**5531**

**USE, OFF-SITE PARKING, BUFFER FENCING, AND  
BUFFER FENCE HEIGHT VARIANCES TO ALLOW  
PARKING IN AN R-1, SINGLE-FAMILY RESIDENTIAL  
DISTRICT, AND OFF-SITE PARKING IN A B-2,  
NEIGHBORHOOD BUSINESS DISTRICT, NO BUFFER  
FENCING FACING ACROSS-STREET RESIDENTIAL  
ZONING, AND TO ALLOW 4' HIGH AND 5' HIGH  
BUFFER FENCE HEIGHTS; THE ZONING ORDINANCE  
DOES NOT ALLOW PARKING IN AN R-1, SINGLE-  
FAMILY RESIDENTIAL DISTRICT, REQUIRES ALL  
PARKING TO BE ON-SITE IN A B-2, NEIGHBORHOOD  
BUSINESS DISTRICT, REQUIRES A 3' HIGH PRIVACY  
FENCE ALONG A PARKING LOT STREET FRONTAGE  
FACING ACROSS-STREET RESIDENTIAL USE, AND  
REQUIRES A BUFFER FENCE TO BE 6' HIGH ALONG  
ADJACENT RESIDENTIALLY USED PROPERTIES.**

**BOARD OF ZONING ADJUSTMENT**

### **ANALYSIS APPLICATION 5531**

# SITE PLAN

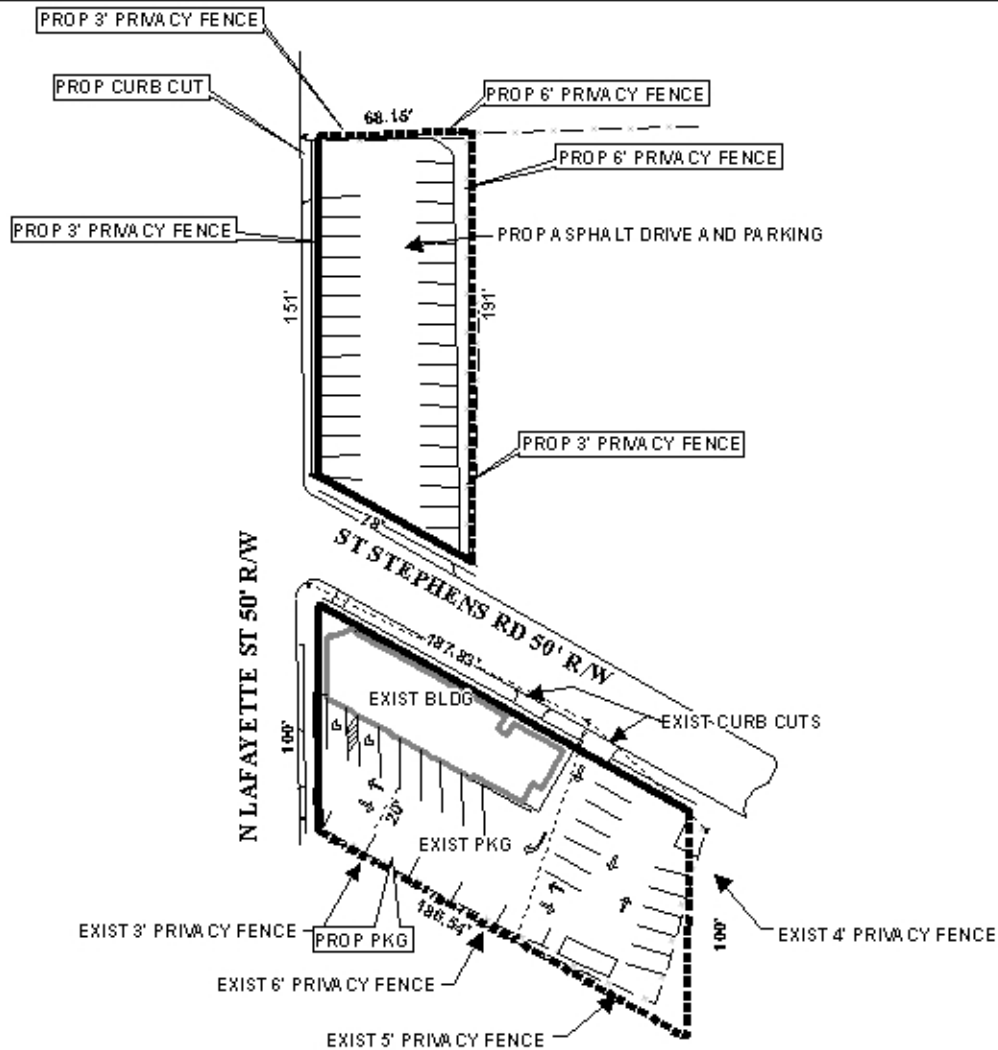
*Traffic Engineering has reviewed the site plan and has determined that it is dysfunctional for the following reasons:*

#### *Lot 1*

- 1) the driveways are not clearly shown;*
- 2) the narrow driveway should be signed "one-way" and/or "do not enter";*
- 3) the driveway radii appear to be less than 20';*
- 4) there is insufficient room for the northern-most parking stall to back out;*
- 5) the 20' wide aisle is too narrow (two-way traffic requires a 24' width).*

#### *Lot 2*

- 1) radii dimensions are not indicated;*
- 2) the asymmetrical stalls must be striped out since they will not accommodate cars;*
- 3) it is unclear if there is to be a drive on the South side, and if so, it should be indicated;*
- 4) the existing Southern most drive on the South side cannot function.*

*As some of the items would require minor site plan revisions and clarifications, others are truly problematic. Two-way drive aisles must be 24' wide, for instance. Also, parts of the parking area and buffer fence on Lot 1 encroach onto the property to the East of the site. An on-site review of the site also revealed the dumpster against that fence, but there is no provision on the site plan for the dumpster and adequate vehicular access.*

*As this application was originally recommended for denial, but was heldover to address specific traffic issues, and since the revised site plan raises more traffic and site issues, this application should not be considered for approval. Also, the fact that the associated Subdivision application was denied at the May 21<sup>st</sup> Planning Commission meeting would effectively annul this application.*
